DOCKETED	
Docket Number:	24-OPT-04
Project Title:	Potentia-Viridi Battery Energy Storage System
TN #:	261419
Document Title:	DR Response 2 - Attachment 17, Revised Section 3-9, Public Health
Description:	This revised section discusses activities that could potentially affect public health as they relate to the construction and operation of the project.
Filer:	Ronelle Candia
Organization:	Dudek
Submitter Role:	Applicant Consultant
Submission Date:	1/29/2025 8:47:05 AM
Docketed Date:	1/29/2025

Attachment 17

Revised Section 3.9, Public Health

3.9 Public Health

PROJECT TITLE:
Construction HRA Receptor Locations

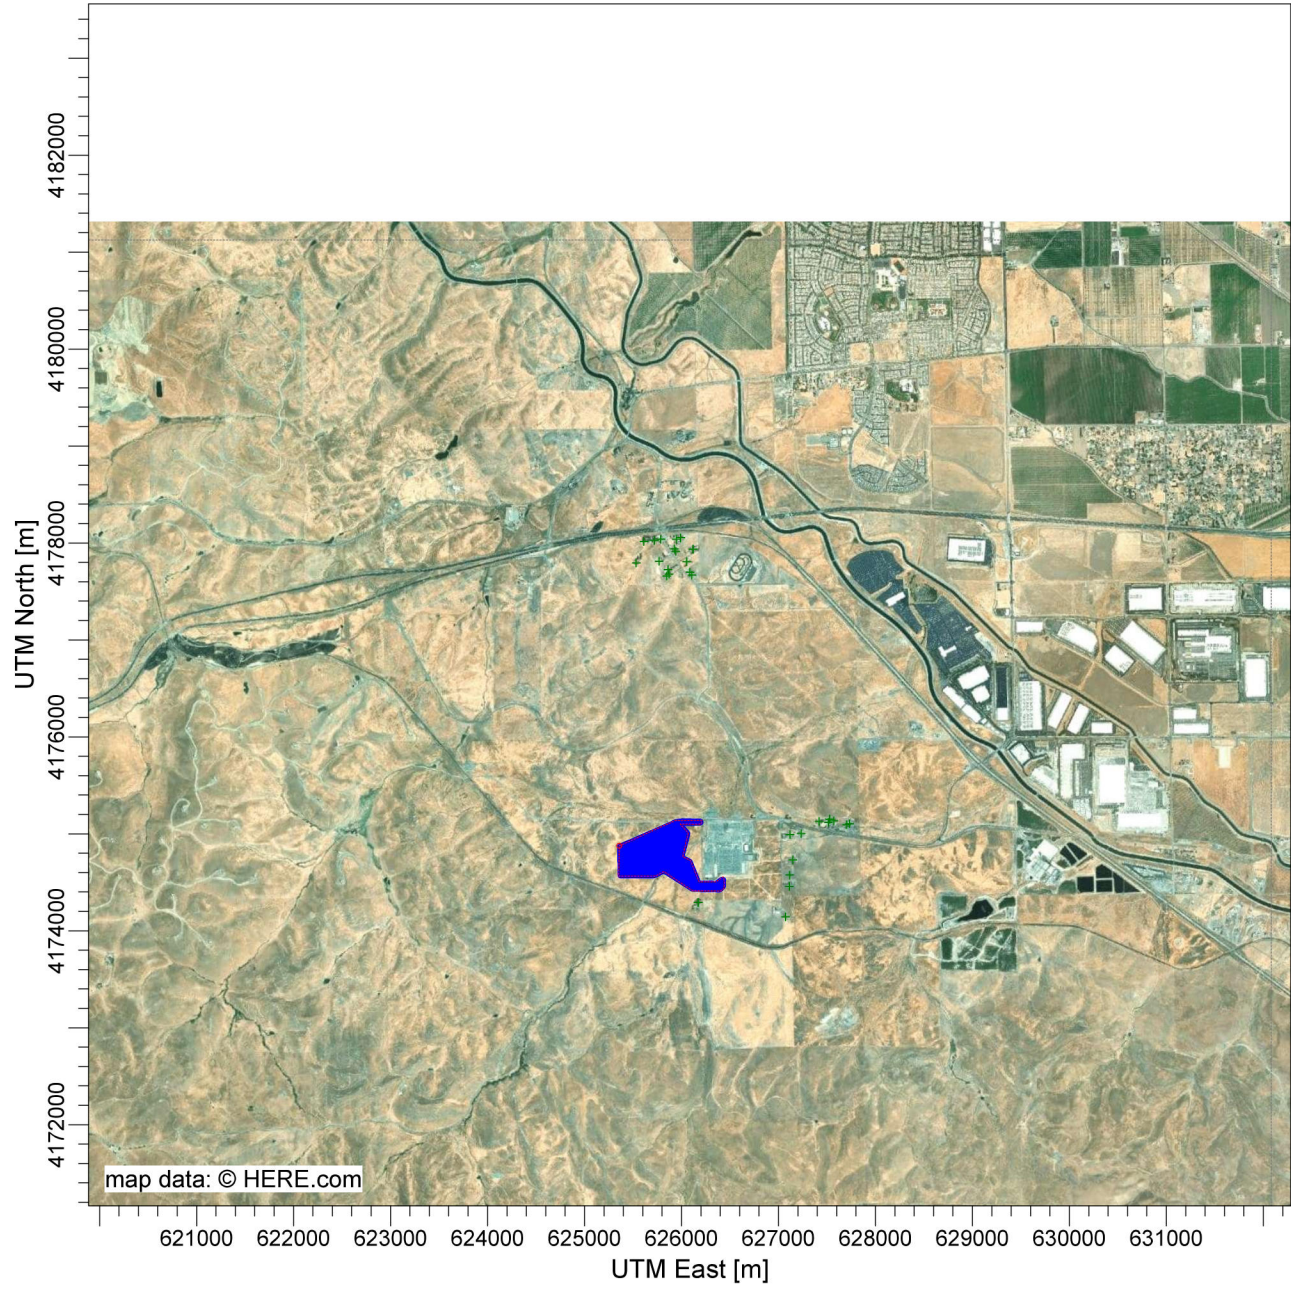
Receptors	Discrete receptors were placed over residences proximate to the Project site. <u>Figure 3.9-1 shows the maximally exposed individual resident, maximally exposed individual worker and the maximally exposed school receptor.</u>

Receptors	Discrete receptors were placed over residences and workplaces proximate to the Project site. Figure 3.9-1 shows the maximally exposed individual resident, maximally exposed individual worker and the maximally exposed school receptor.
